**MONTICELLO NUCLEAR GENERATING PLANT**  
Docket No. 50-263 License No. DPR-22

License Amendment Request  
Revised Pressure and Temperature Curves

License Amendment Request  
Revised Pressure and Temperature Curves

Figure 3.6.3 Minimum Temperature vs. Pressure Mechanical Heatup or Cooldown Without the Core Critical

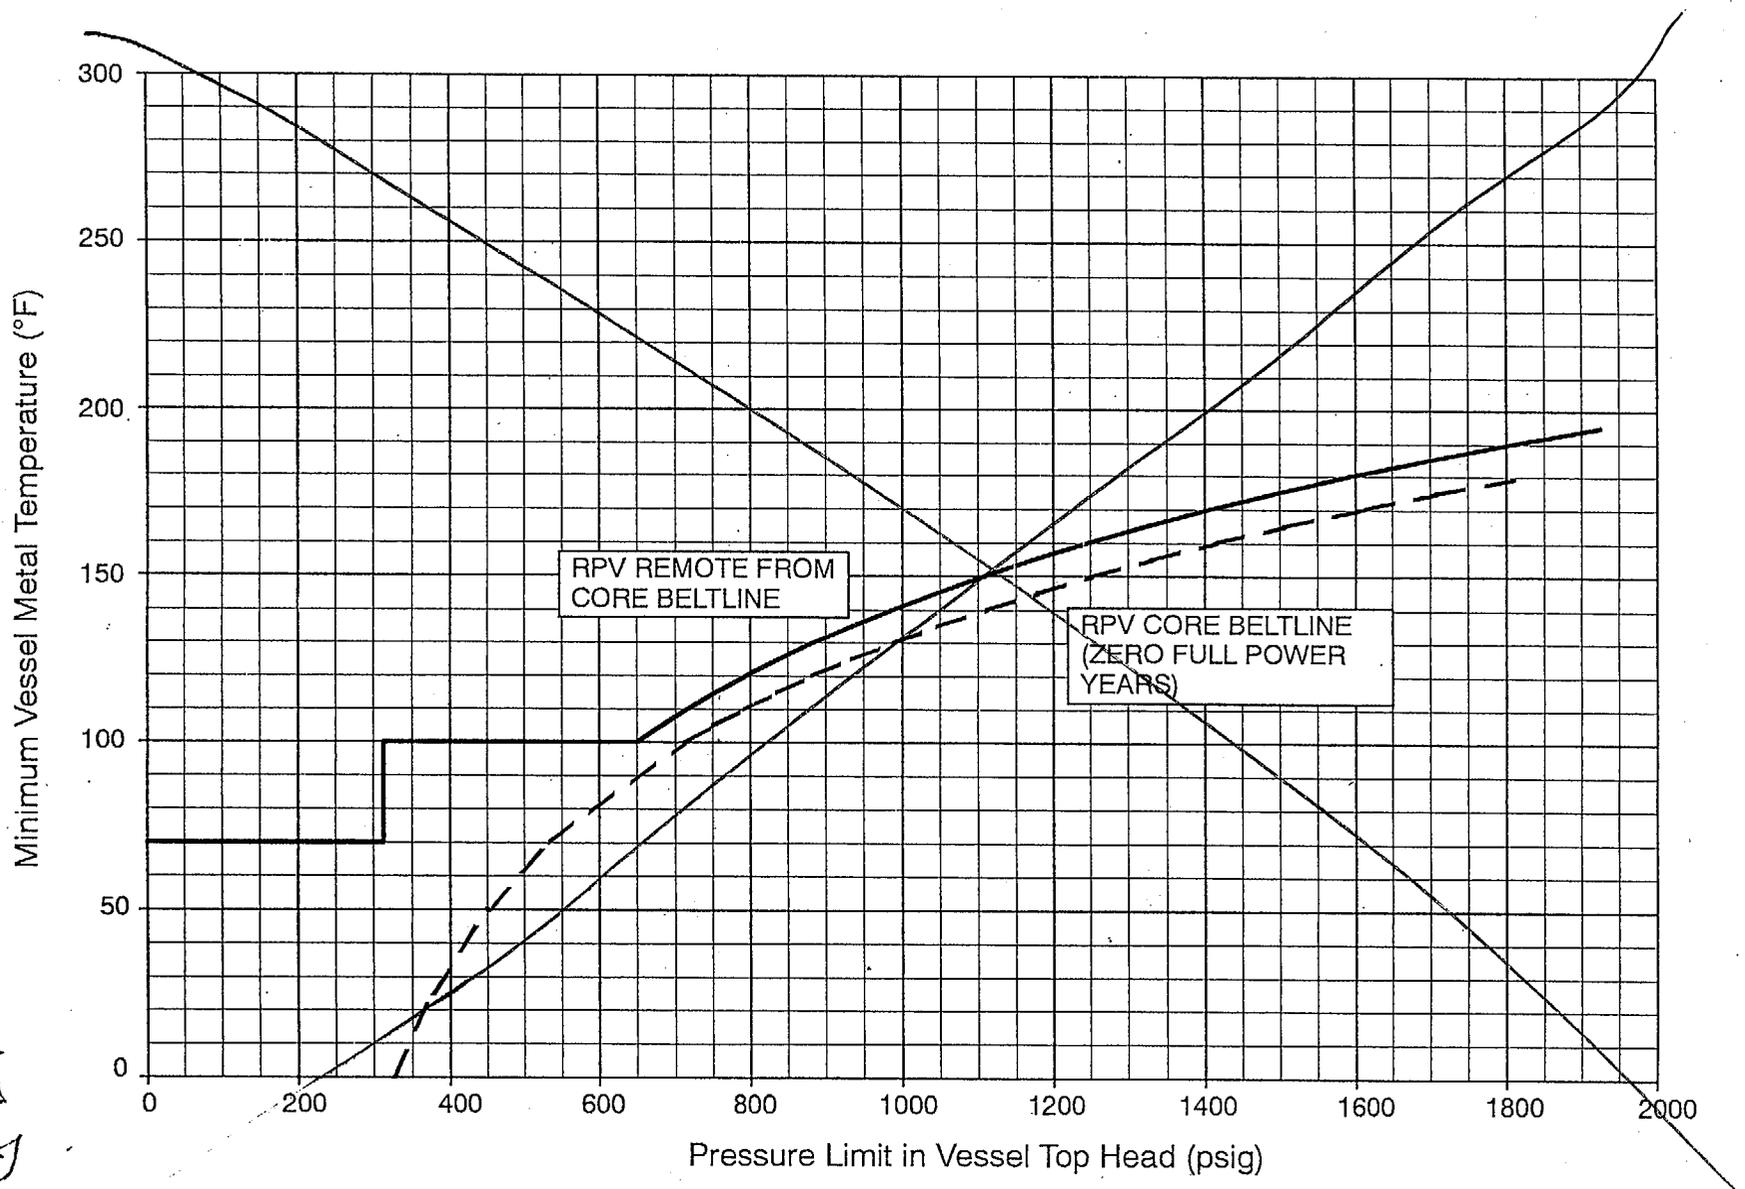
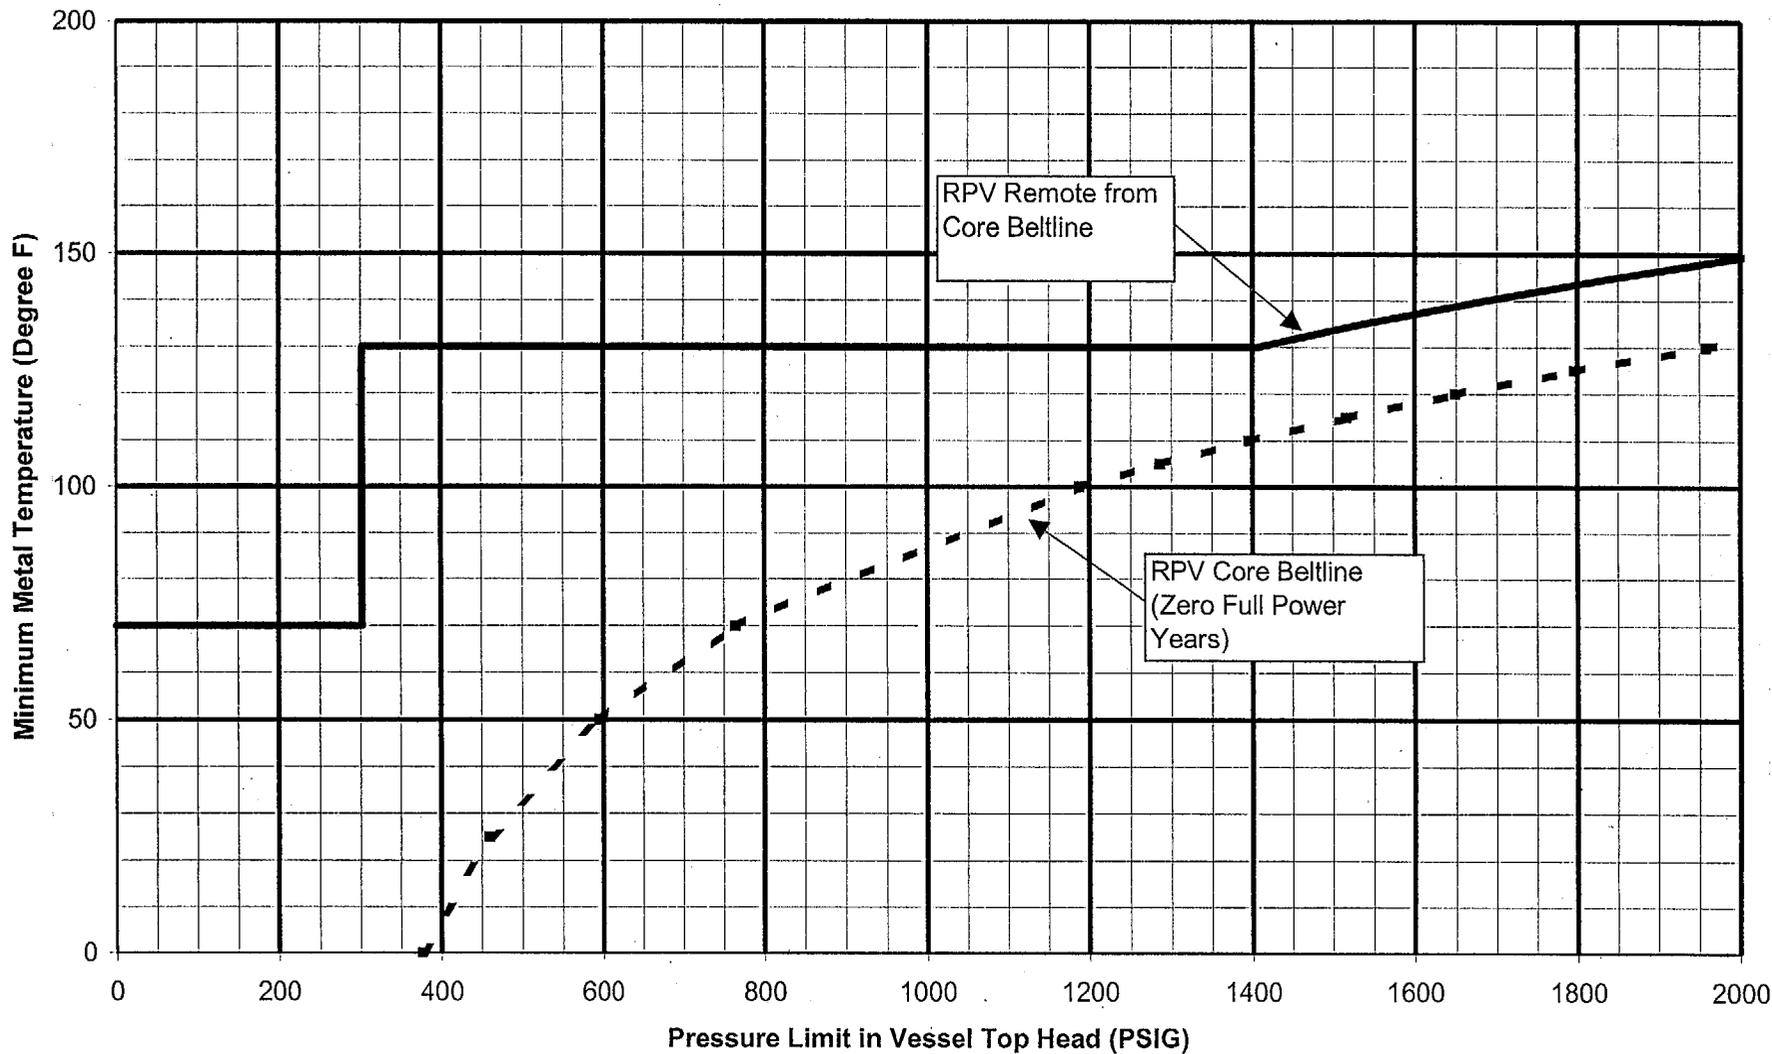
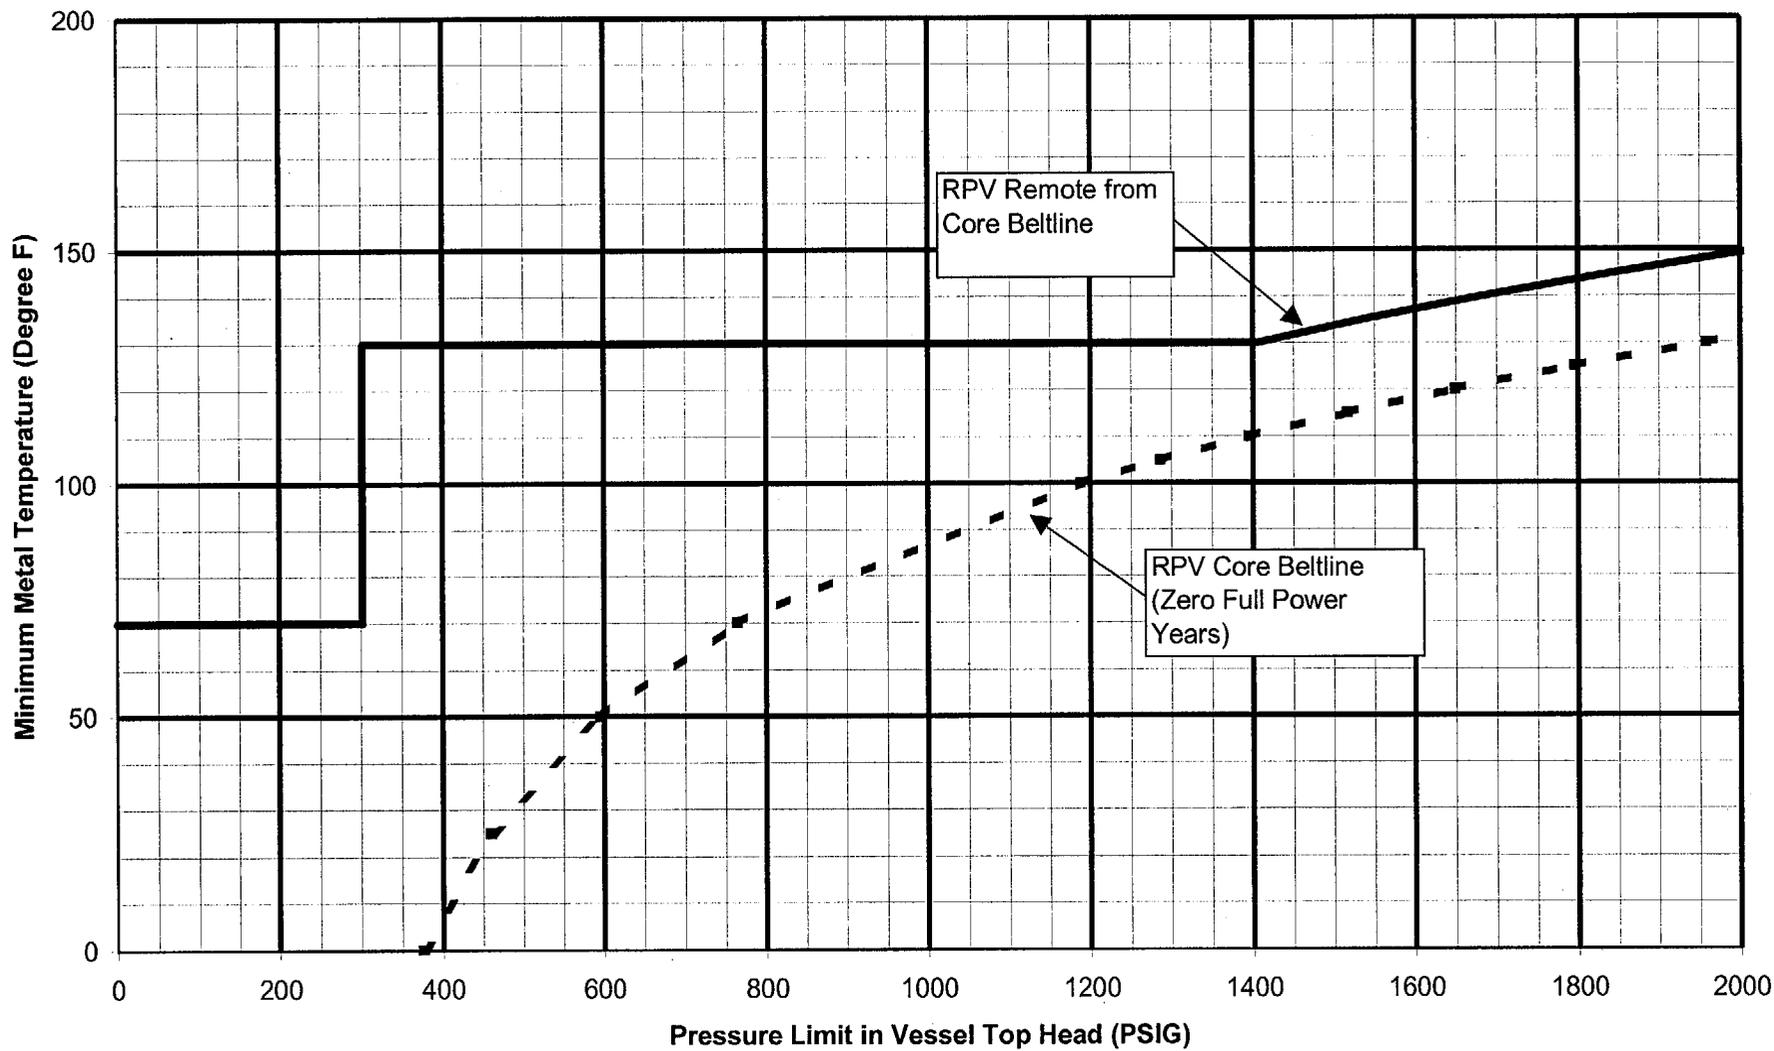
NMC proposes to revise the Monticello TS requirements for reactor pressure vessel (RPV) P/T limit curves. Changes are proposed to Monticello TS Figures 3.6.2, 3.6.3 and 3.6.4 which show the P/T limit curves for inservice leakage and hydrostatic testing, non-nuclear heatup and cooldown, and criticality. No changes to the Limiting Conditions for Operation or any Surveillance Requirements of Technical Specification 3.6.B are proposed.

INSERT ATTACHED
